ADDENDUM NO. 03
TO THE
CONTRACT DOCUMENTS

FOR
TAXIWAY A REHABILITATION (WEST)

AT
SYRACUSE HANCOCK INTERNATIONAL AIRPORT
SYRACUSE, NEW YORK

AUGUST 11, 2023

IN-PAVEMENT L-852G(L) RUNWAY GUARD LIGHT
 NOT TO SCALE
 (ITEM L-125-501) 3
ED-04

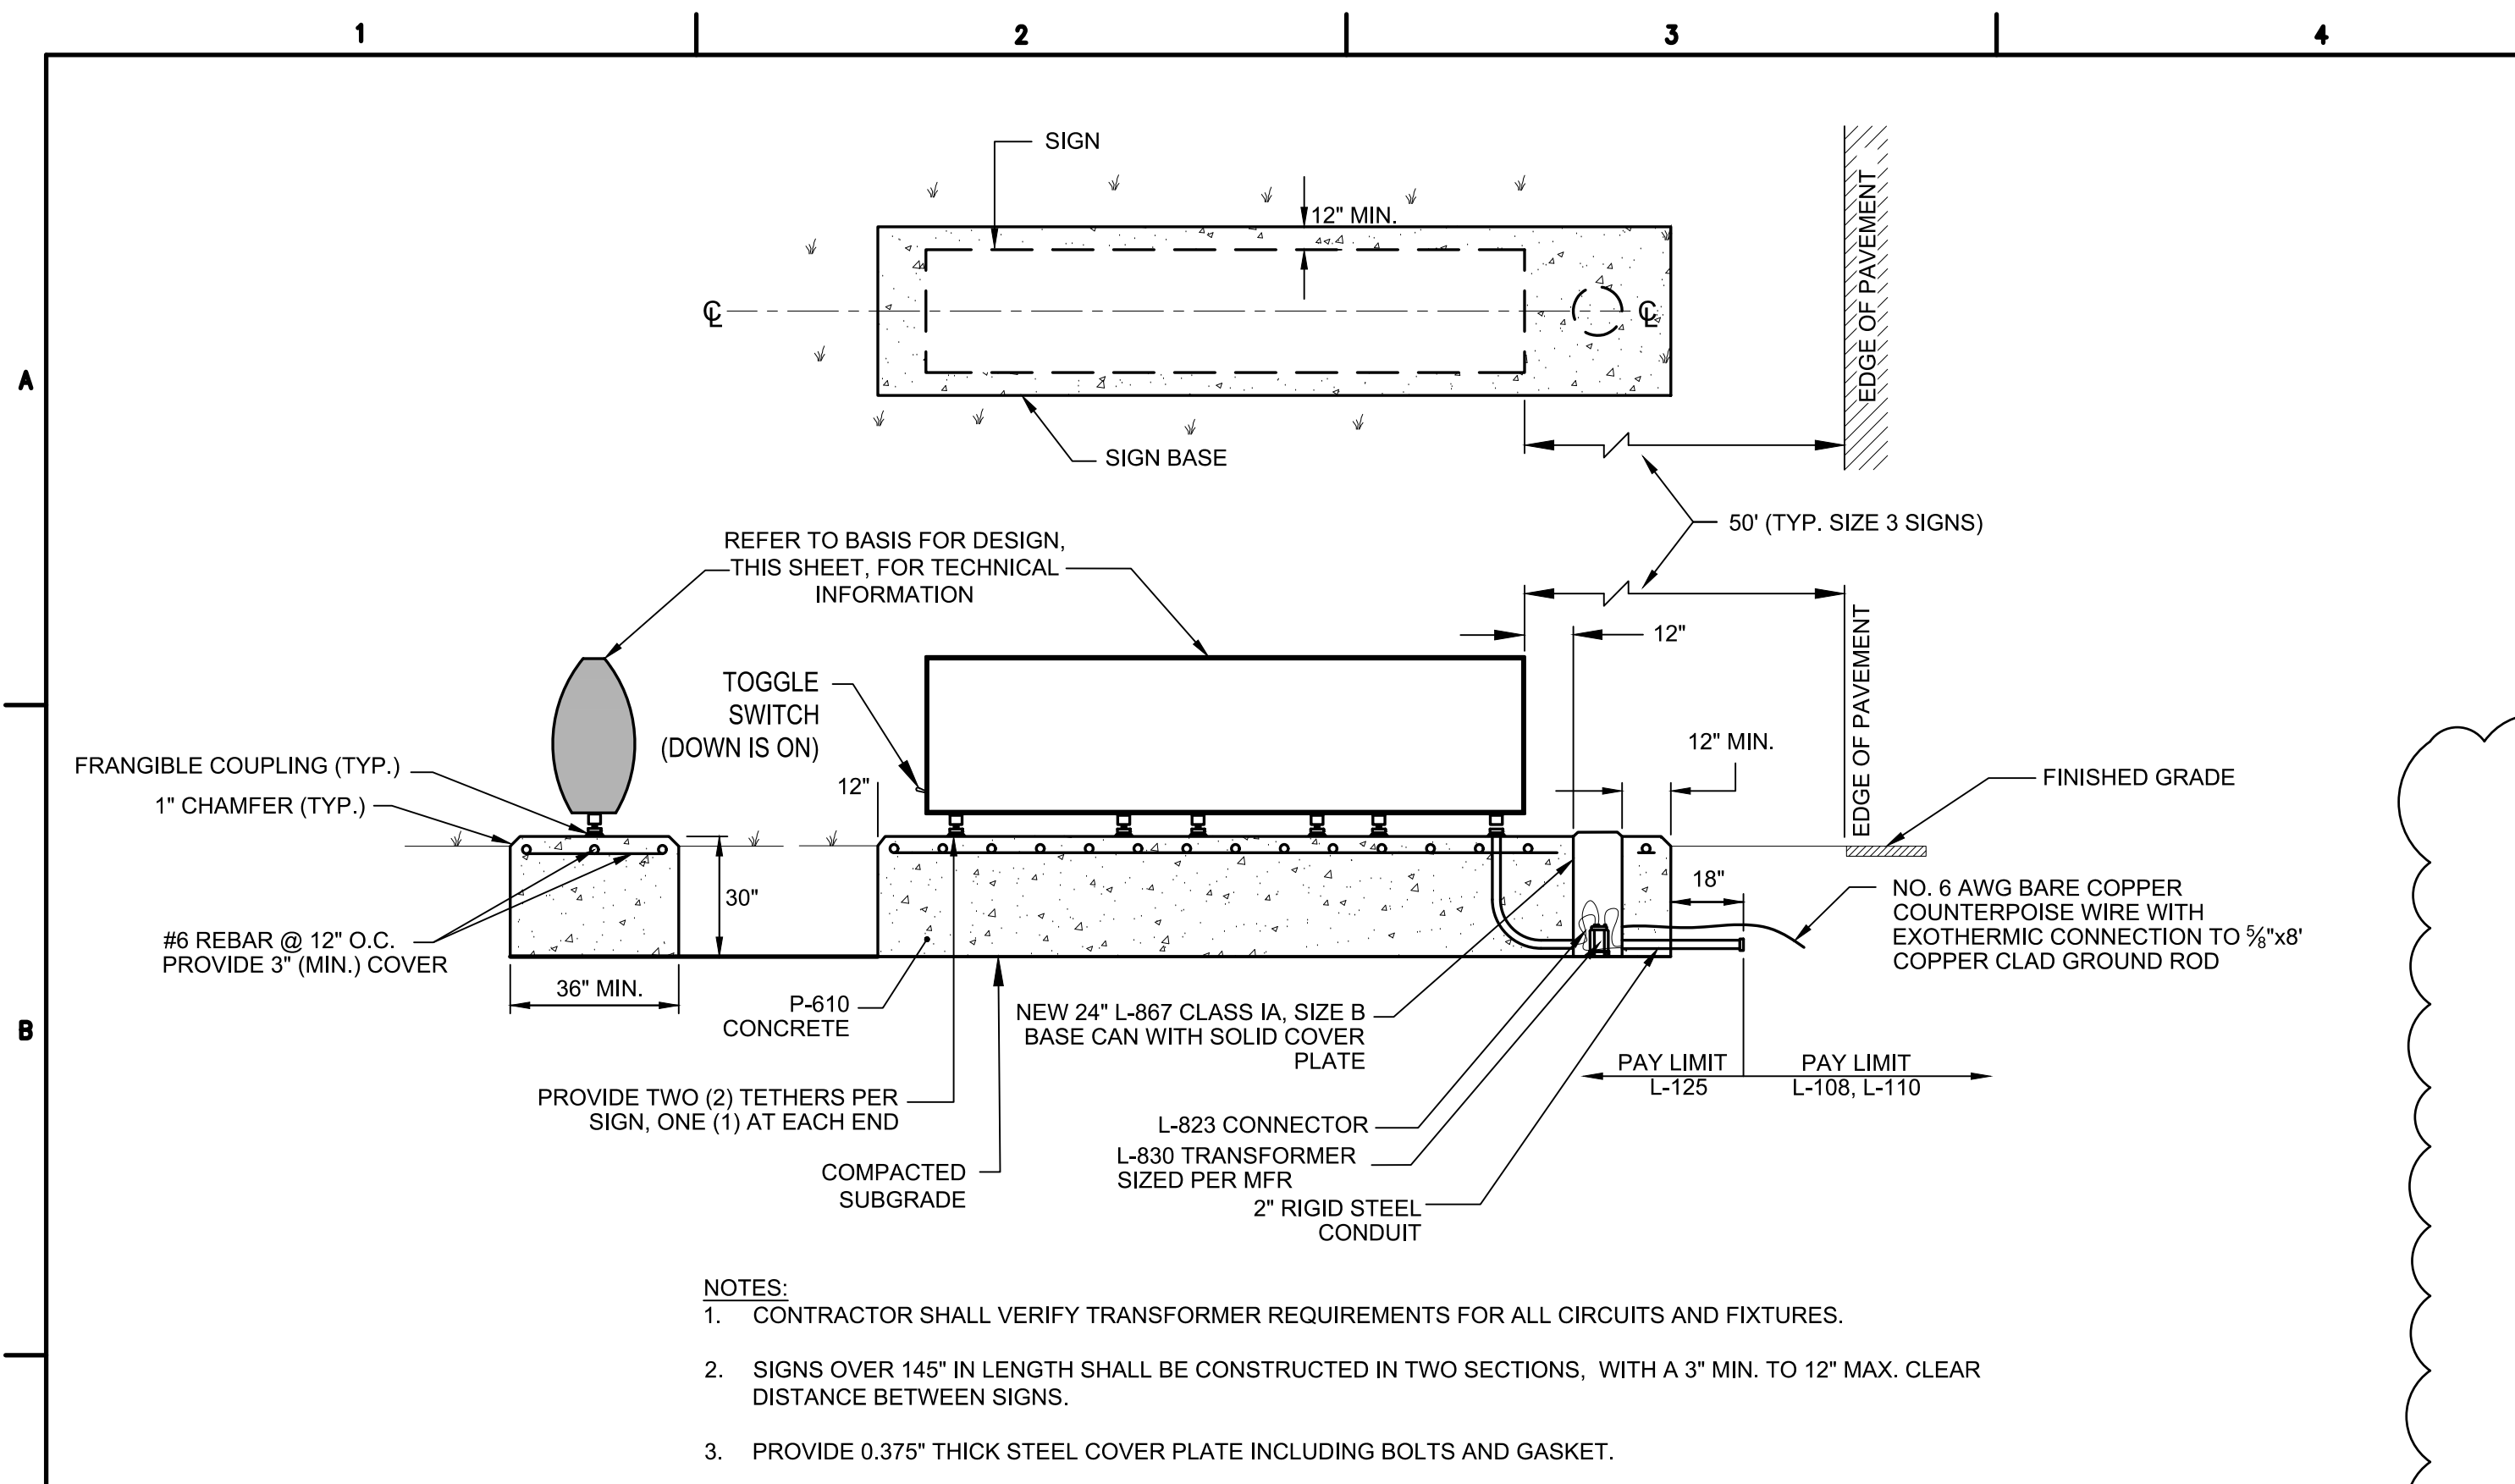
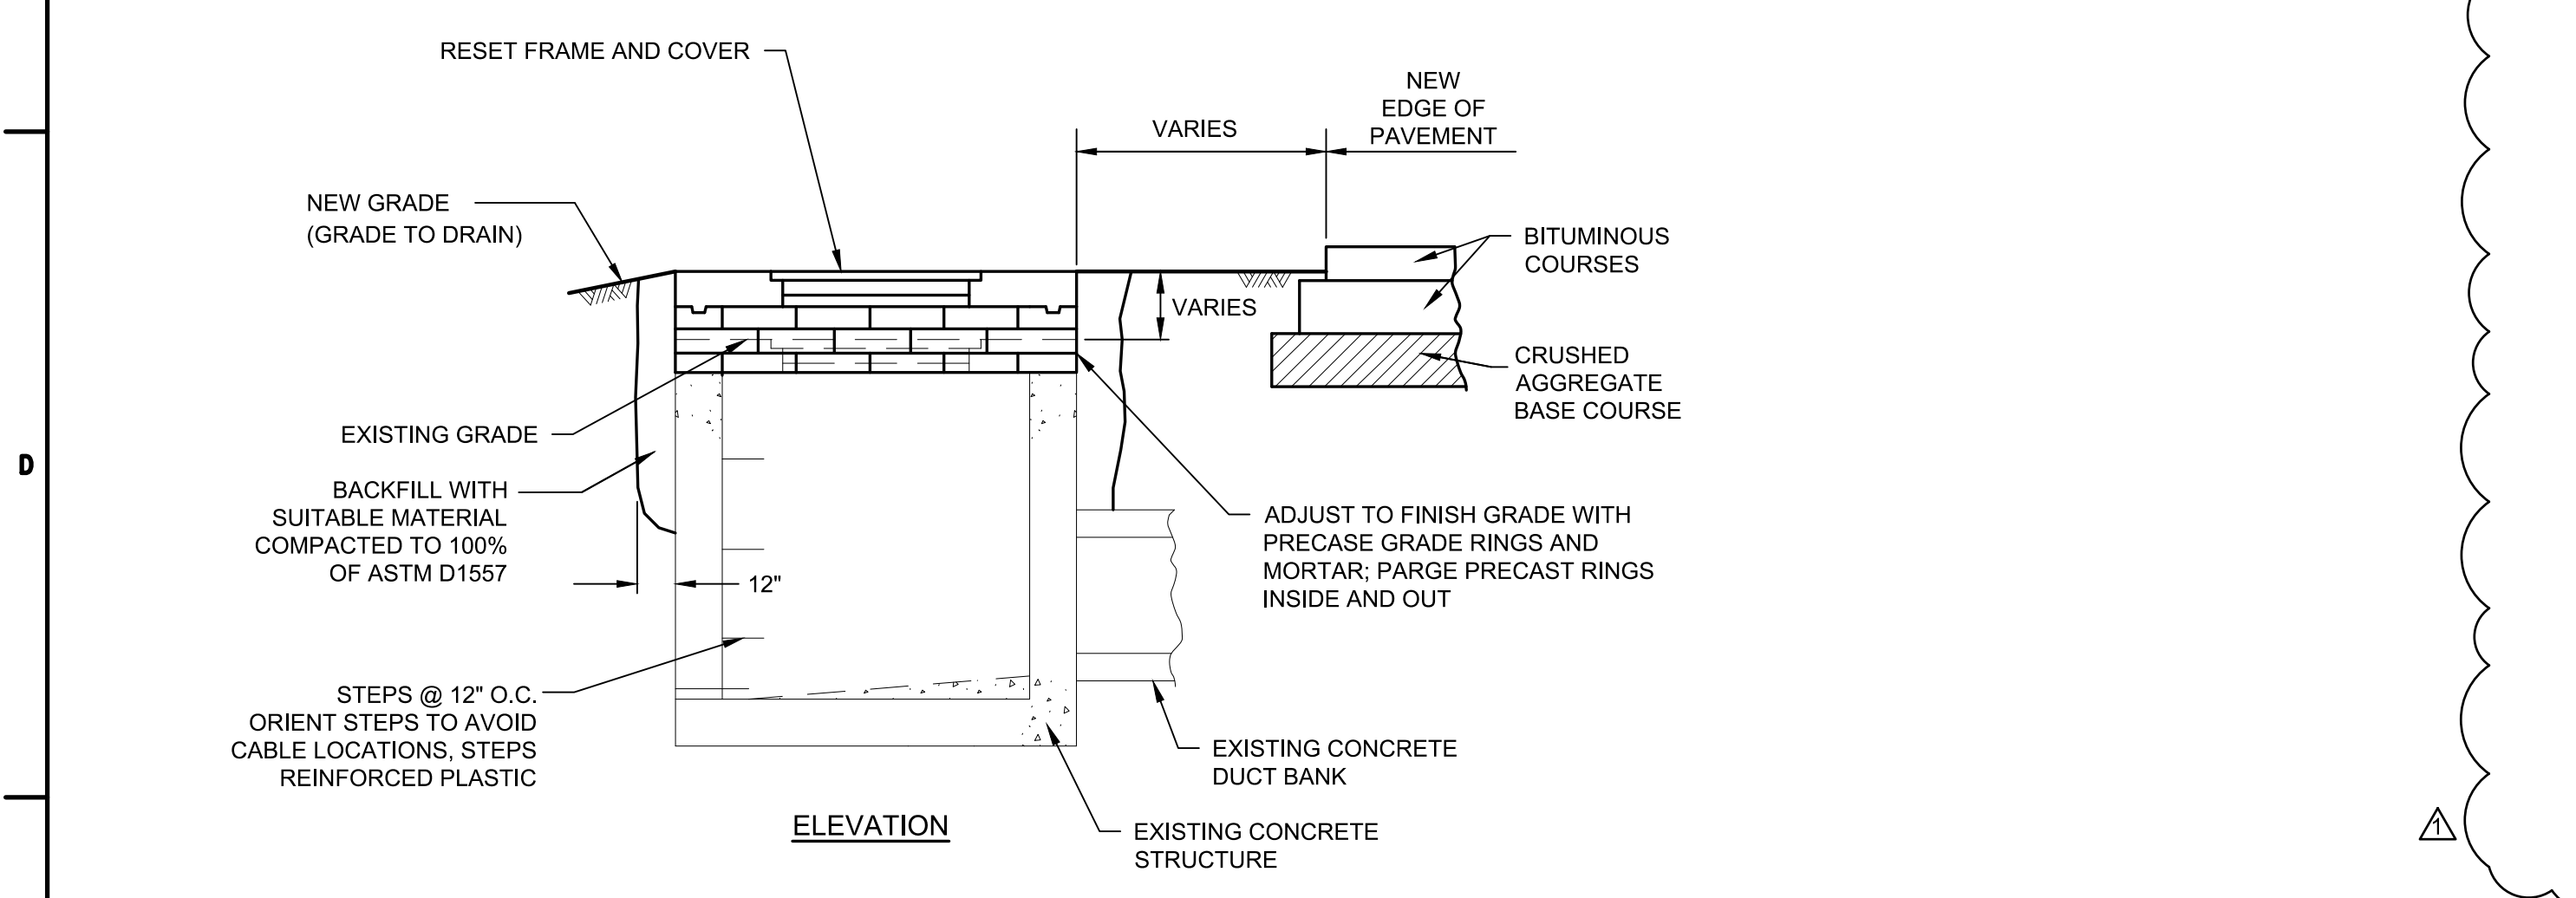
Clarification: Details and notes have been revised to reflect correct equipment specifications and address erroneous discrepancies. Additional details pertaining to Runway Guard Lights have been added. Detail sheet numbers have been revised on individual detail labels to correct erroneous entries.

REV	DATE	DESCRIPTION	BY
	8/11/2023	ADDED DETAIL SHEET NUMBERS - ADDENDUM 3	SGJ
	8/11/2023	ADDED RGL DETAIL - ADDENDUM 3	SGJ
